PG&E Letter DCL-03-047

Docket No. 50-275, OL-DPR-80
Docket No. 50-323, OL-DPR-82
Diablo Canyon Units 1 and 2
Response to NRC Request for Additional Information Regarding License
Amendment Request 02-03, "Spent Fuel Cask Handling"

**PG&E Response to NRC Request for Additional Information Regarding License
Amendment Request 02-03, "Spent Fuel Cask Handling"**

FIGURE 5.1-1 (3 of 3)

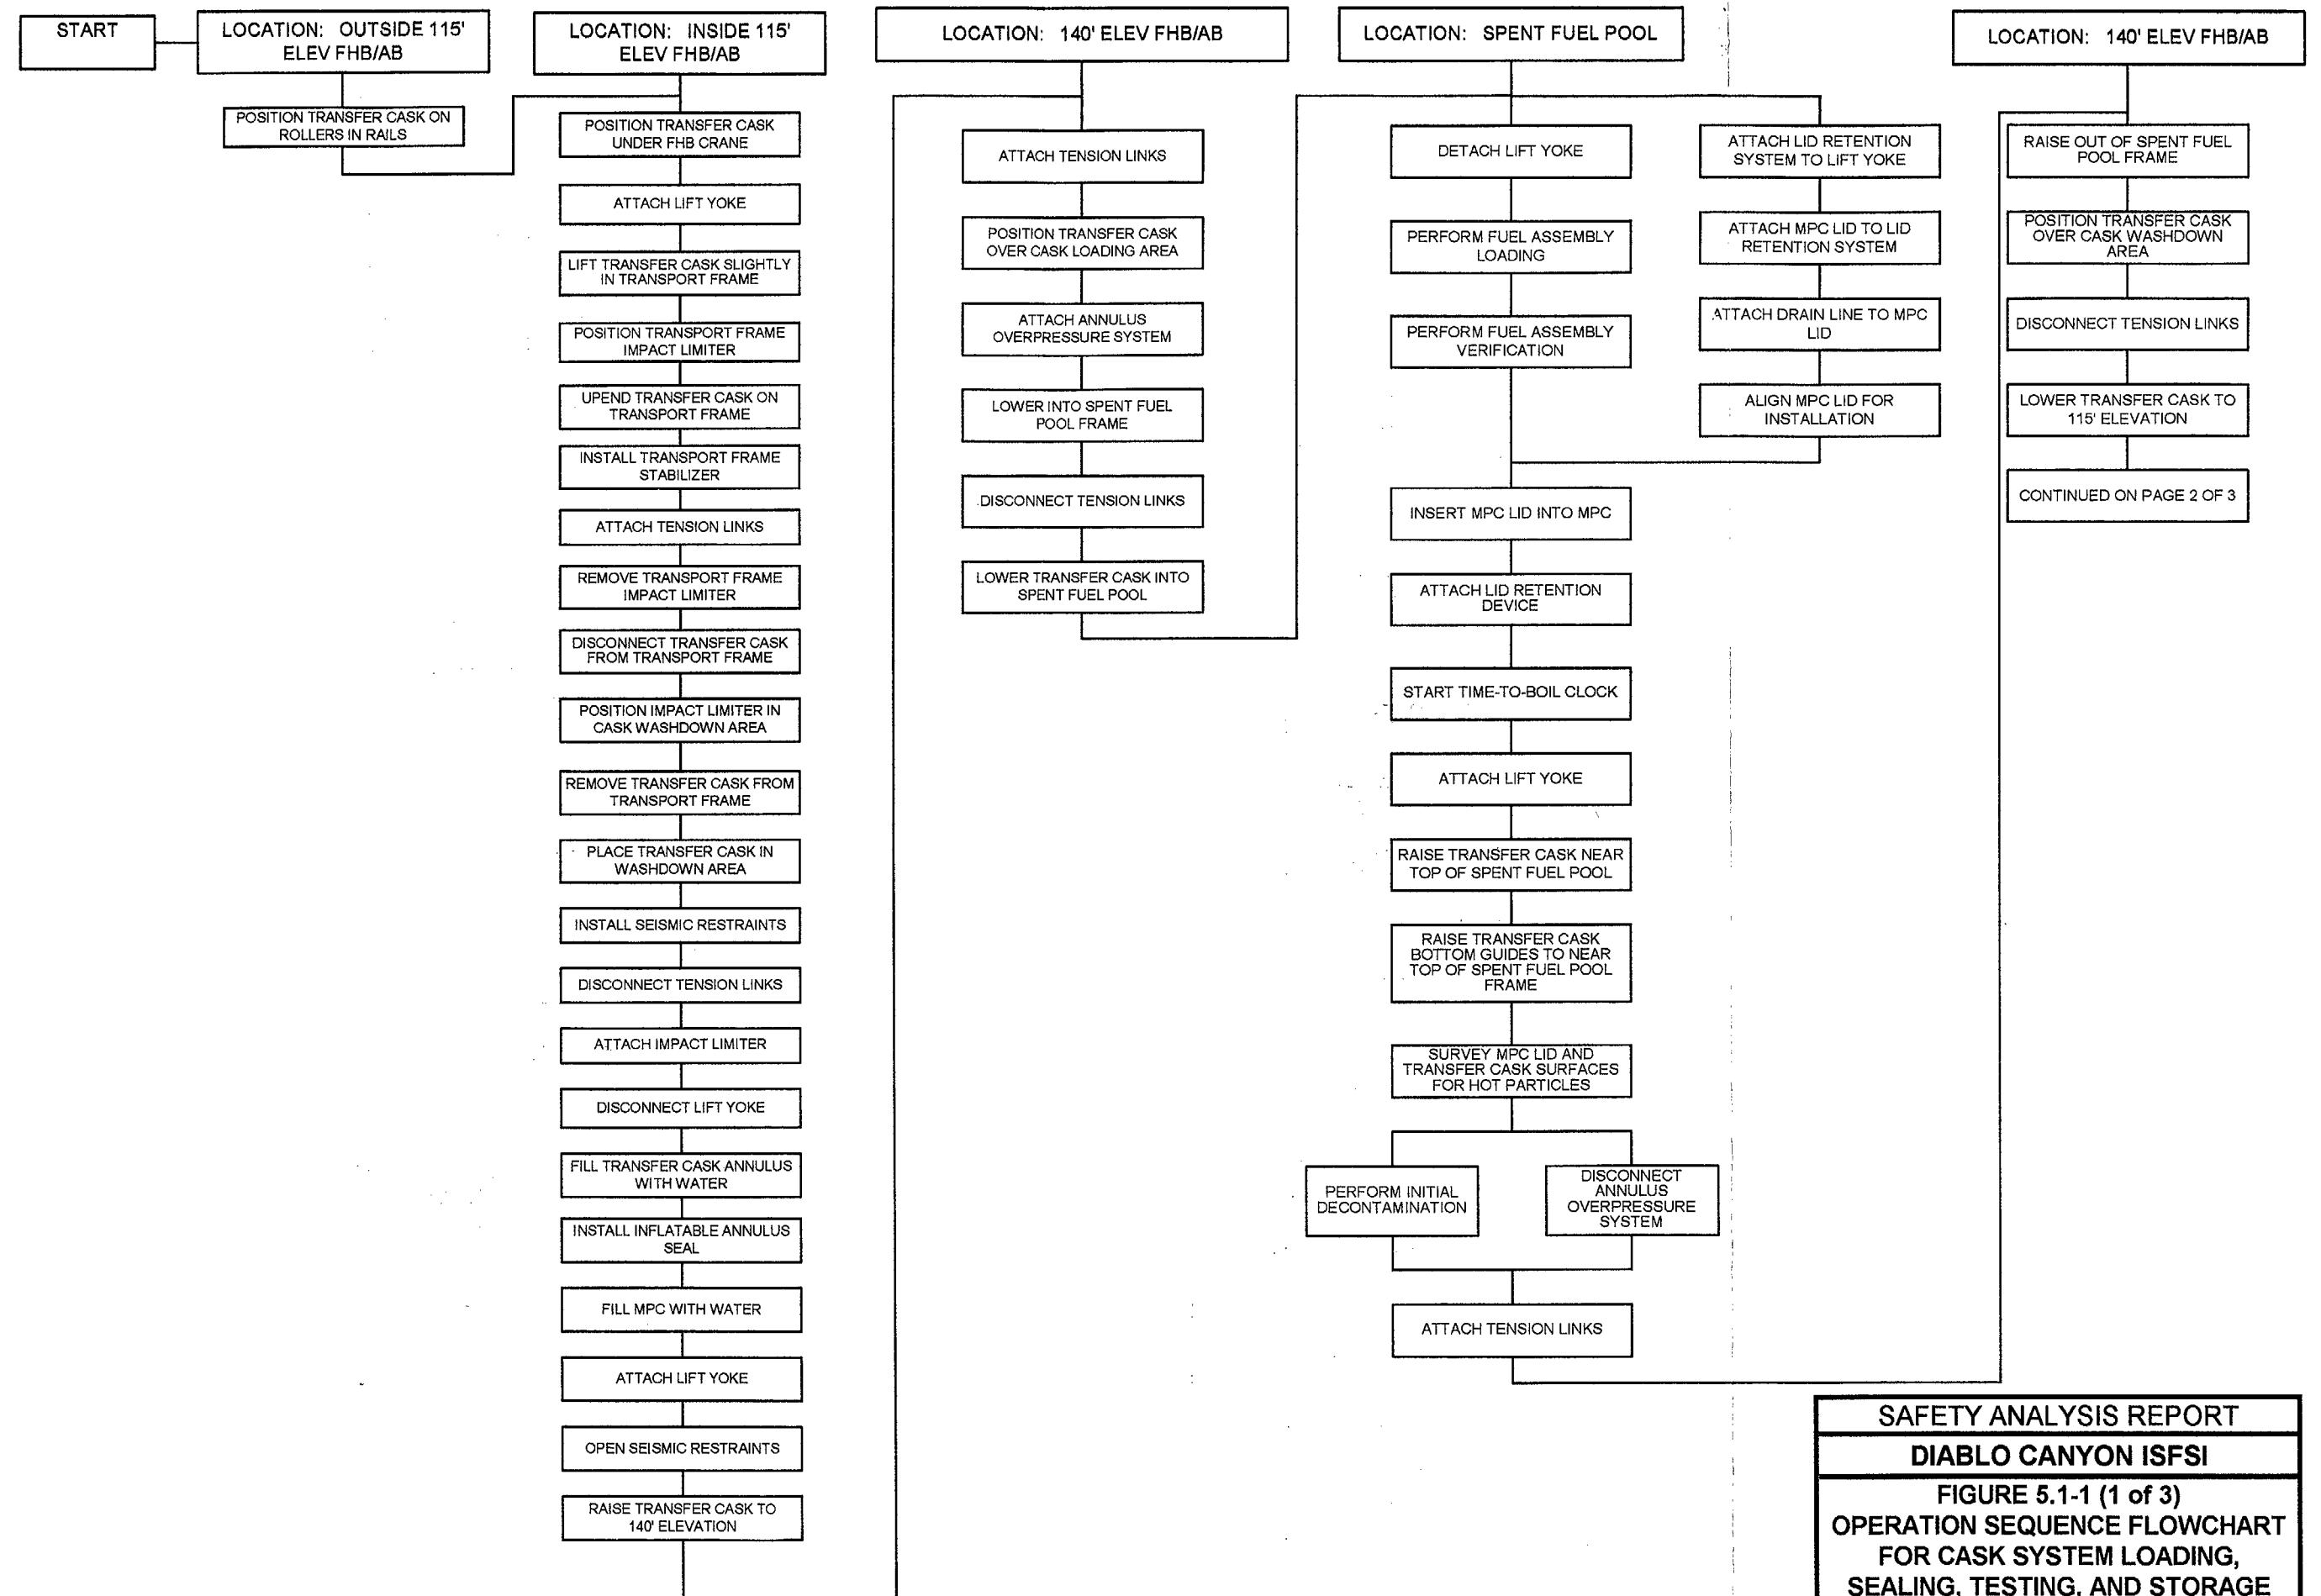
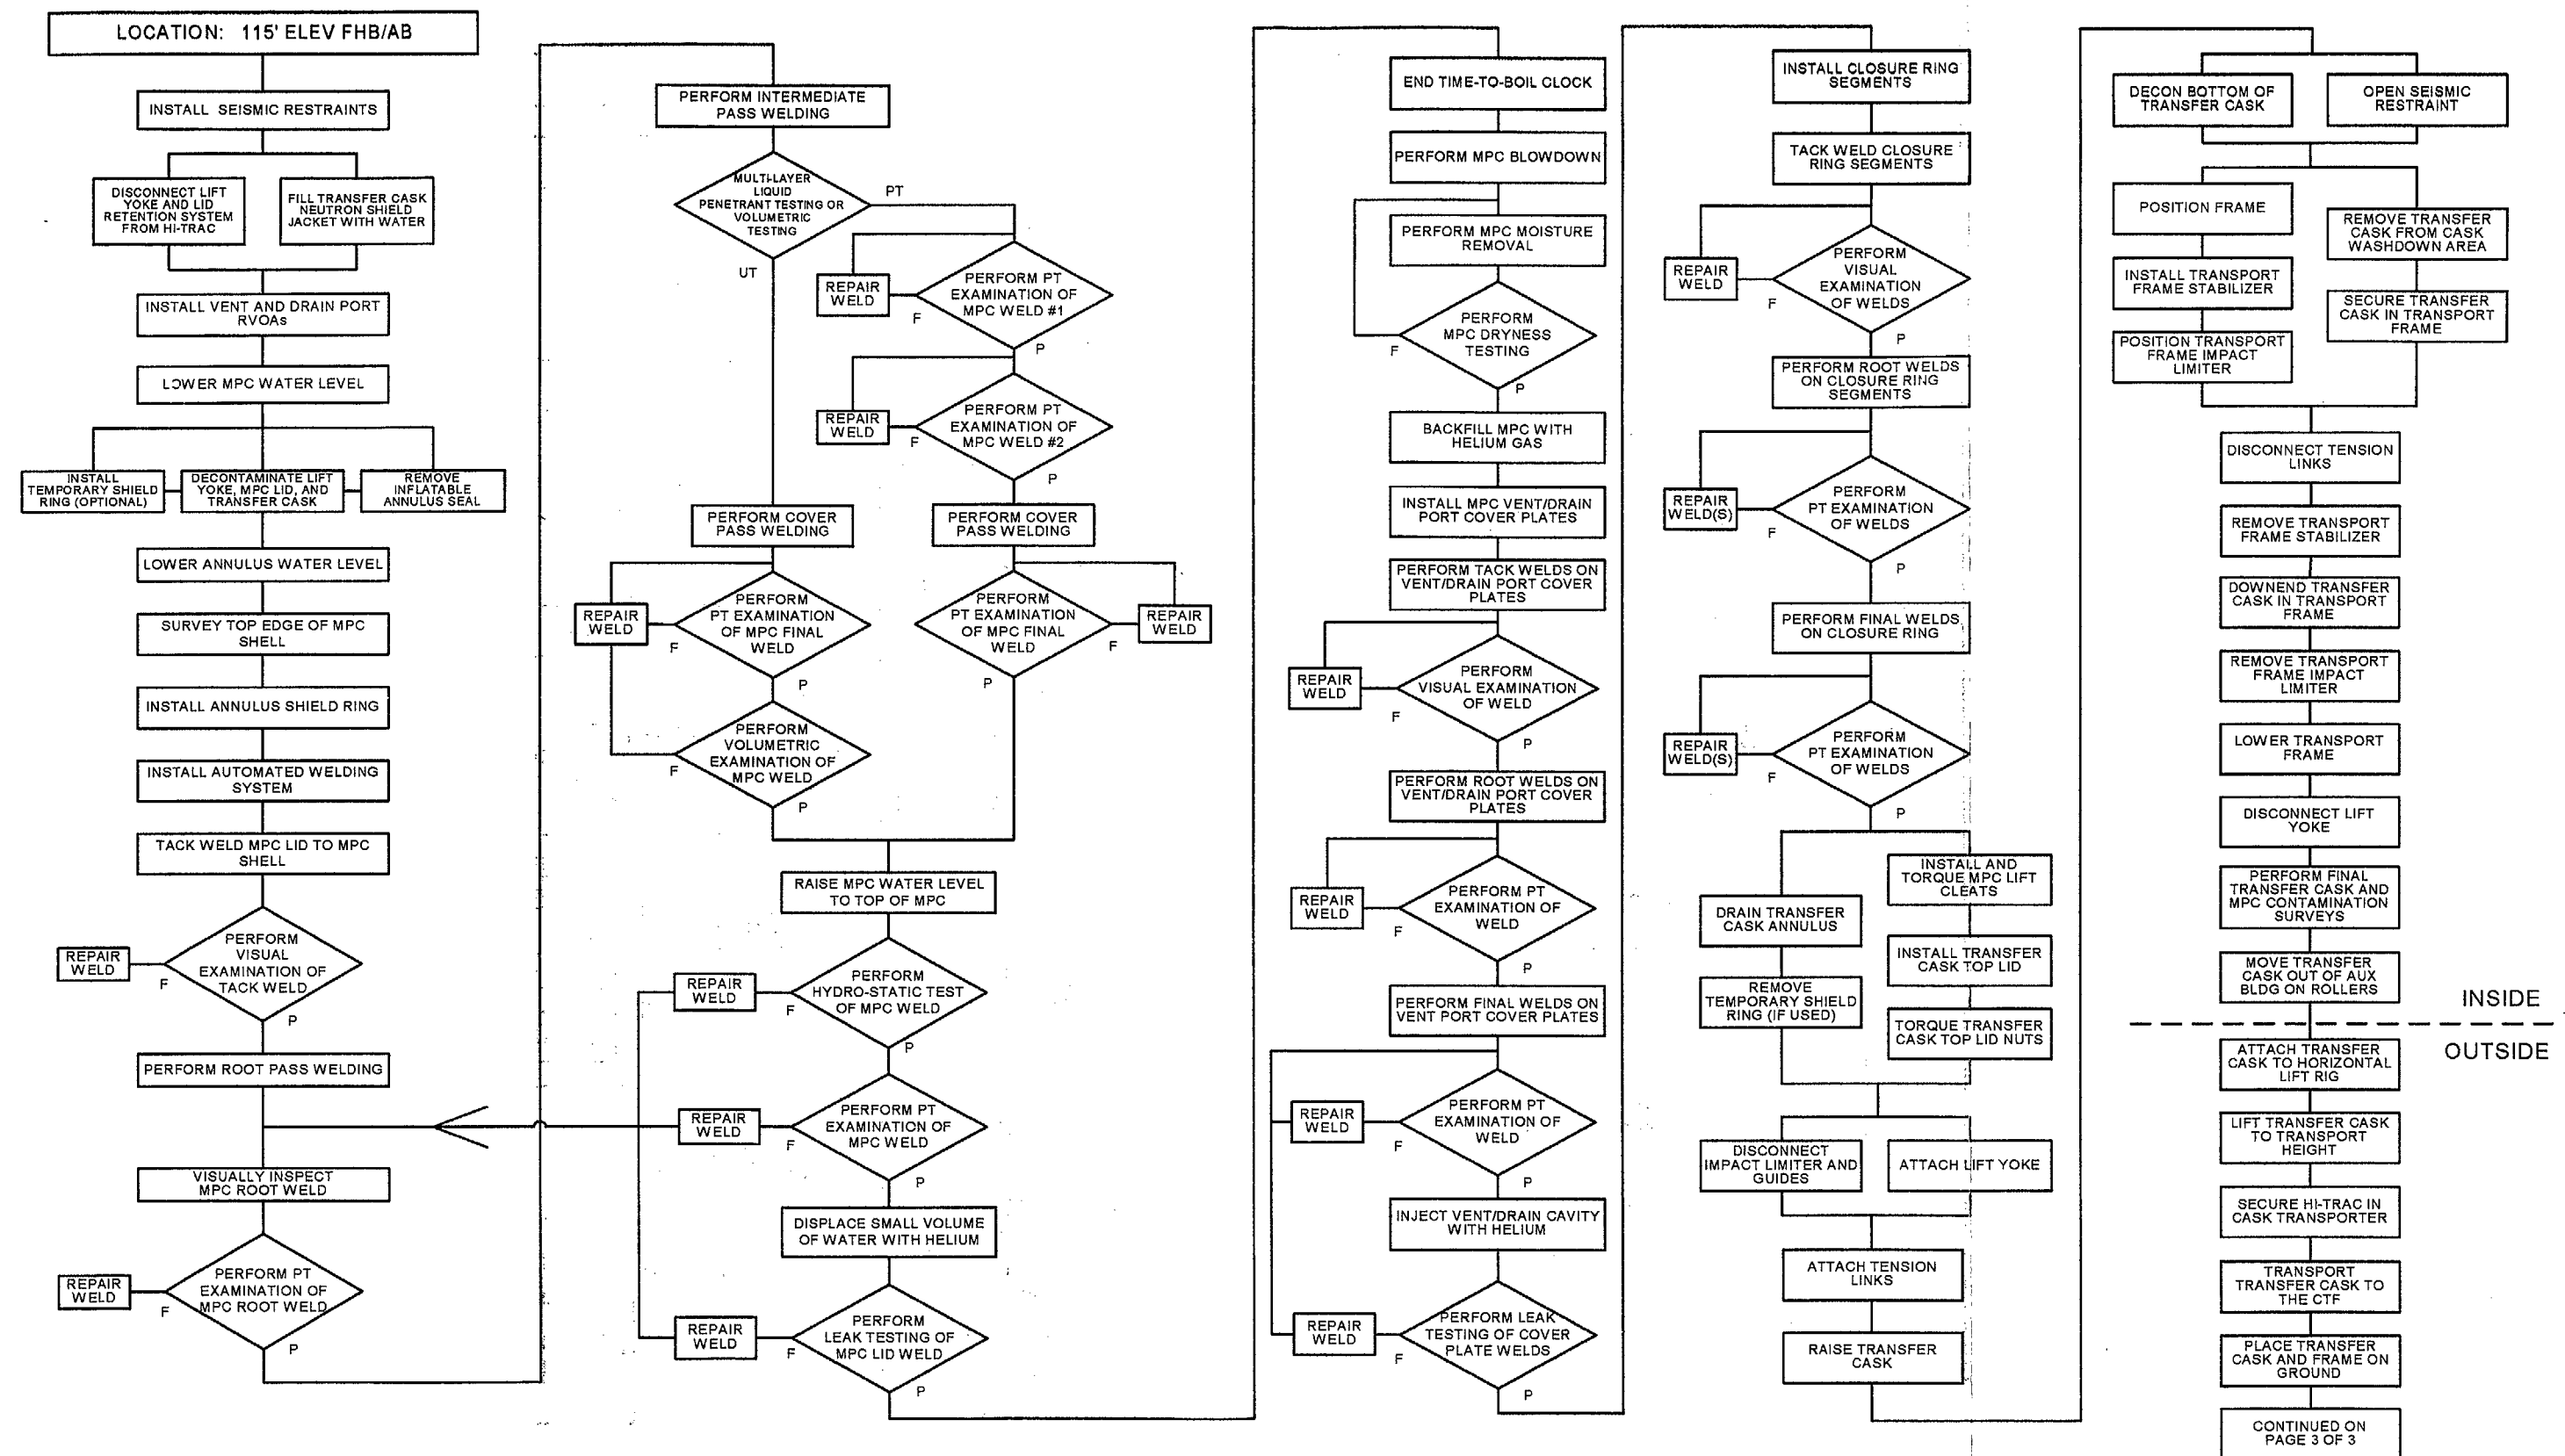
The Diablo Canyon Power Plant (DCPP) license amendment request to revise the DCPD updated final safety analysis report (UFSAR) regarding its control of heavy loads program proposes to eliminate the spent fuel cask exclusion zone. The UFSAR restricts cask movement to the portion of the spent fuel pool which is over the cask recess area. The defense-in-depth approach within NUREG-0612, "Control of Heavy Loads at Nuclear Power Plants," states that despite the increase reliability of the overhead handling system licensees should (1) provide sufficient operator training, handling system design, load handling instructions, and equipment inspection to assure

reliable operation of the handling system; and (2) define safe load paths through procedures and operator training so that to the extent practical heavy loads avoid being carried over or near irradiated fuel or safe shutdown equipment. Provide your basis for eliminating the cask exclusion area? Demonstrate how the defense-in-depth philosophy described will be maintained through your cask handling operations supporting your proposed independent spent fuel storage installation (ISFSI).

An operational sequence depicting the cask handling operations is presented in the enclosed Diablo Canyon ISFSI SAR Figure 5.1-1, which was previously submitted in PG&E Letter DIL-01-002 dated December 21, 2001 under Docket No. 72.26. Using LAR Figures 8 and 9 along with the sequence presented, provides a "pool to pad" map of cask handling operations.
